RESOLUTION NO. 2015-032

A RESOLUTION ADOPTING STATEWIDE URBAN
DESIGN AND SPECIFICATIONS

**Amendments to the Statewide Urban Design and Specifications (SUDAS)
Design Standards Manual and Specifications Manual by the City of Tiffin
Approved Date: 11 March, 2015**

2.) Figures G-1.02 and 2G-1.03 show typical installation details.

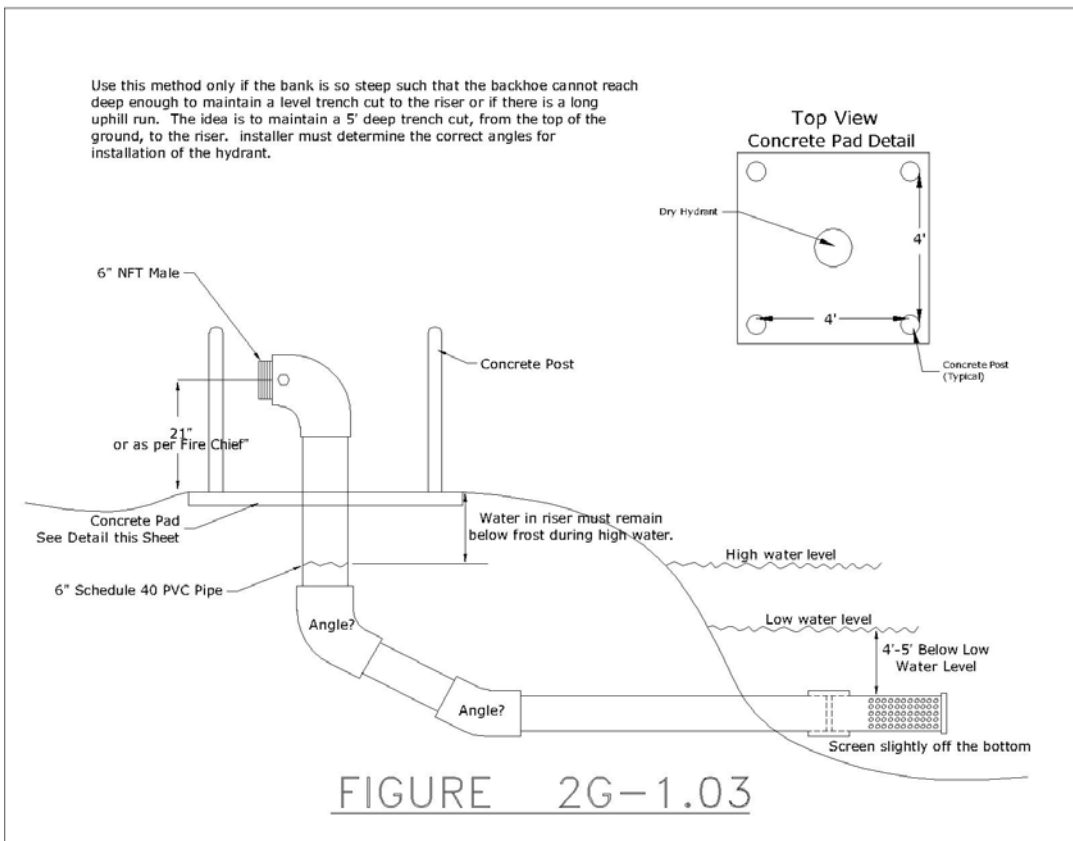
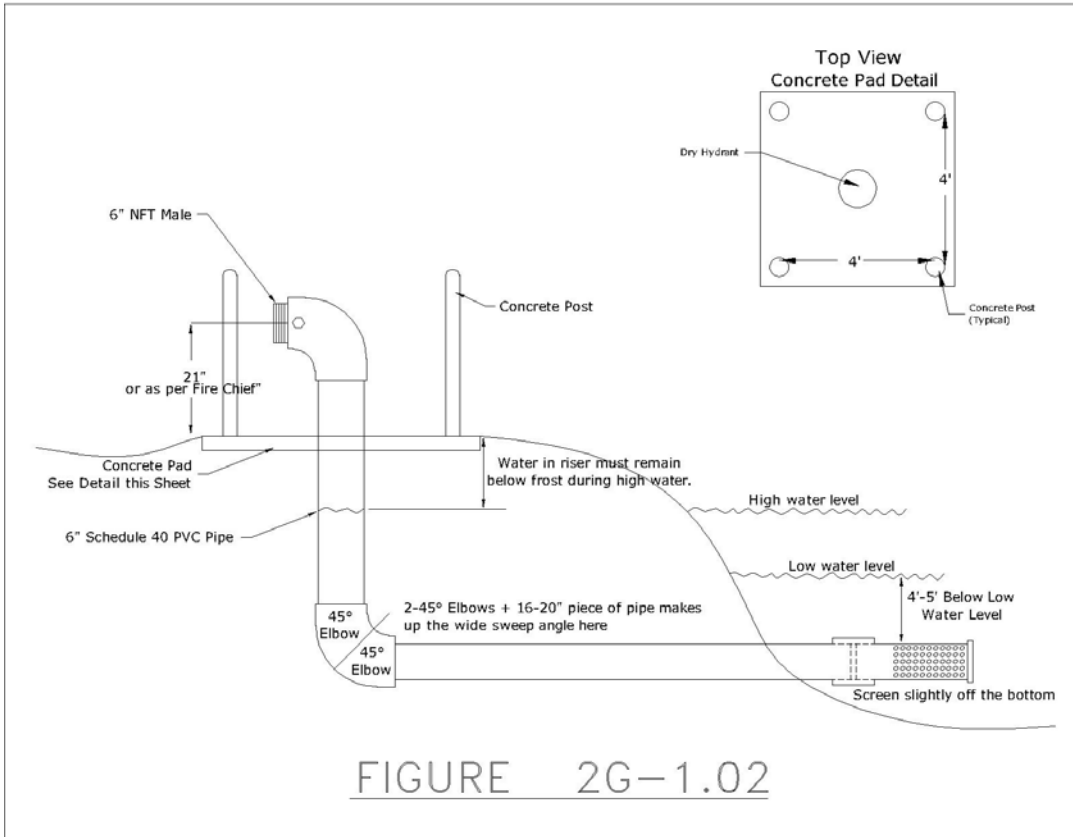
a. Dry Hydrant Installation

1.) All wet-bottom detention facilities shall have an emergency vehicle accessible dry hydrant installed. Additional information regarding installation is available at the Office of the City Engineer. All dry hydrants installation sites will be approved by the Fire Chief and construction drawings will be approved by the Fire chief and City Engineer.

Figure 5M-1.07 shows a typical roadway cross-section at an entrance.

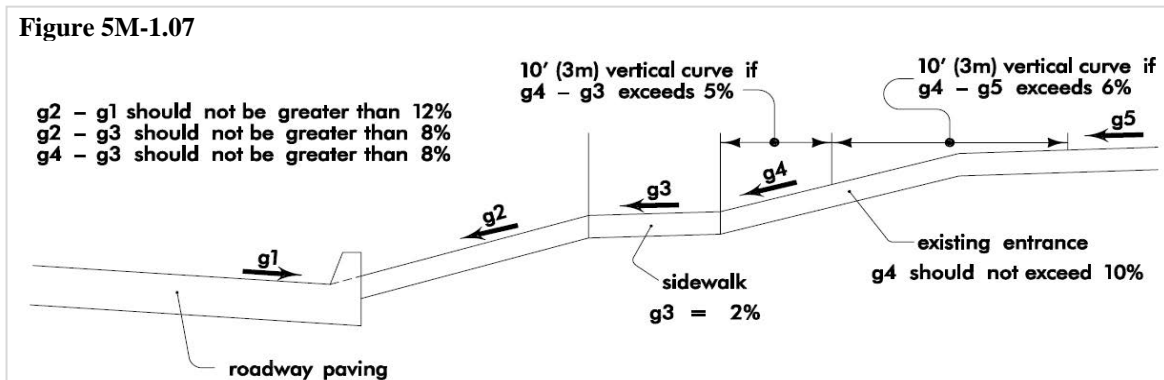
G. Driveway Grades

Figure 5M-1.08 shows a typical design vehicle for driveway design.

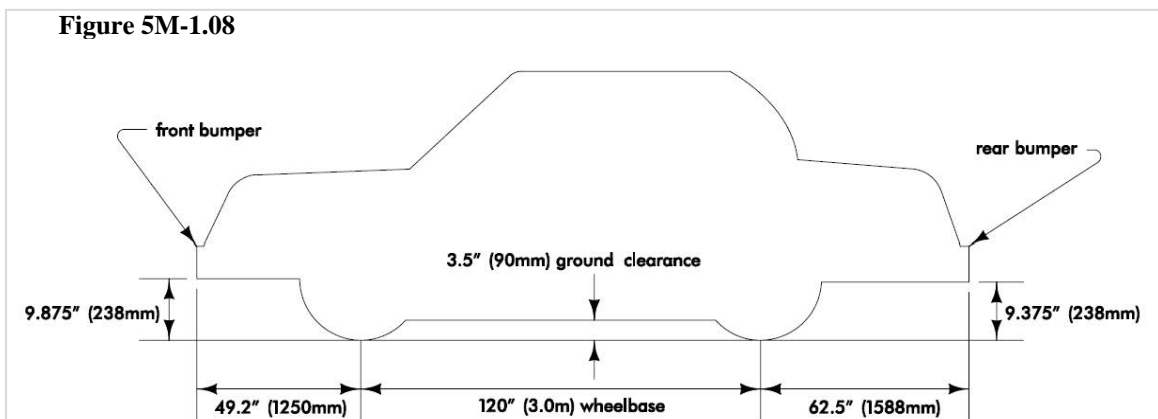
The information in this paragraph should be used as a guide for driveway design. In all cases, Figure 7030.103 of the SUDAS Standard Specification shall apply. The entrance profile ($g2$) should slope upward (positive grade) from the gutter line to the curb side of the sidewalk (if present) with a maximum algebraic difference of 15% between the cross slope of the traveled way ($g1$) and the positive slope of the driveway ($g2$). Vertical curves should be used if $g4-g3$ exceeds 5% or if $g4-g5$ exceeds 5%. The designer should check the entrance profile with a template similar to Figure 5L-1.08 to ensure ample vertical clearance between the driveway surface and the underside of the design vehicle in the maximum range. The designer should also consider any special vehicles that may use the entrance, such as limousines or campers, to ensure ample vertical clearances exist for these vehicles.
